## ADDENDUM #2

Project Name: Renovations to:  
1350 Edgmont Avenue  
Chester, PA 19013

Prepared for: Chester Upland School District  
1350 Edgmont Avenue  
Chester, PA 19013

Date: 02/23/2023

# M101

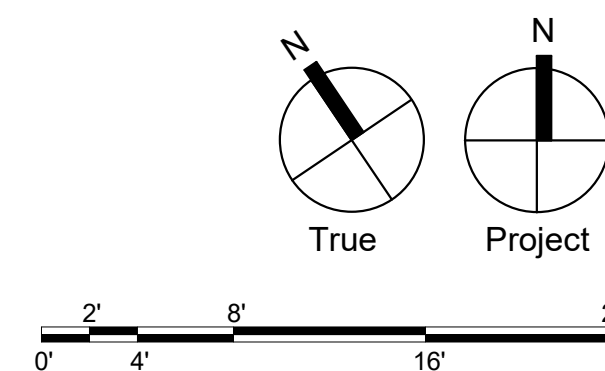
- 2.09 Drawing M101:
  - **REVISED** ductwork in S1 STAIR corridor to include Fire/Smoke Combination Dampers.
  - **ADDED** duct smoke detectors to ductwork in S1 STAIR corridor.
  - **REVISED** ductwork in C103 CORRIDOR.
  - **REVISED** ductwork in 36 JANITOR.
  - **REVISED** ductwork in C102 CORRIDOR.
  - **REVISED** ductwork in A105 SGI.
  - **REVISED** ductwork in 68 SPRINKLER ROOM.
- 2.10 Drawing M102:
  - **REVISED** ductwork in 62 STAIR corridor to include Fire/Smoke Combination Dampers
  - **ADDED** duct smoke detectors to ductwork in 62 STAIR corridor.
- 2.11 Drawing M600; **REVISED** VAV box schedule for VAV-1.6 & VAV-1.9.
